ADDENDUM NO. 2

DATE: January 27, 2020
FROM: Village of Villa Park Public Works Department
TO: All Plan holders
PROJECT: **S Cornell Pumping Station Emergency Generator Replacement**

Title: S CORNELL PUMPING STATION
1260 S CORNELL AVE, VILLA PARK, IL
EMERGENCY GENERATOR REPLACEMENT
DETAILS

GAS PIPING DETAIL

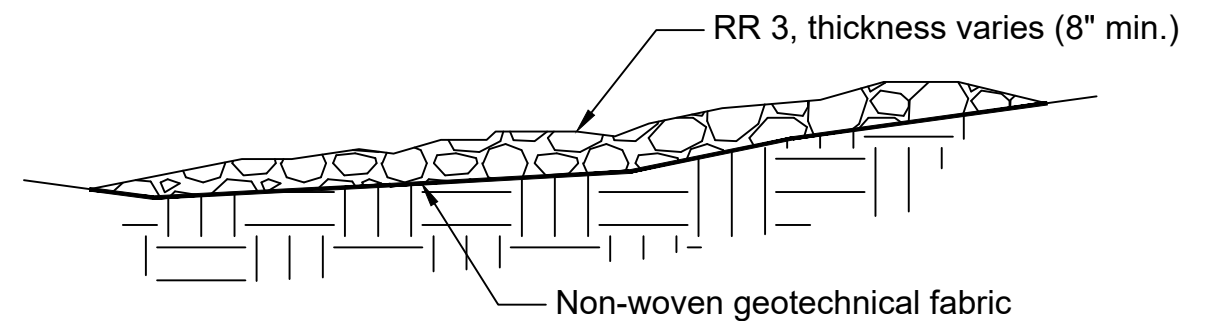
Replace Sheet 6 of the plans with the attachment included in this addendum. A detail was added for gas piping.

No.	Date	Nature of Revision	Scale:	
1	1/27/20	Add gas piping detail	Designed by:	
			Checked by:	
			Approved by:

1. All piping is gas-rated steel pipe and 2" diameter unless noted otherwise.
2. V is the Customer Fuel Line Cut Off Valve supplied and installed by gas company.
3. U is gas-rated union joint.
4. R is Maxitrol Model 210E pressure regulator or approved equal with Violet spring rated for 4"-12" water column pressure.
5. Vent on pressure regulator is 1/2" NPT with 13A25 vent protector.
6. F is fuel filter provided by generator manufacturer.
7. Piping supports to be provided per gas company requirements.
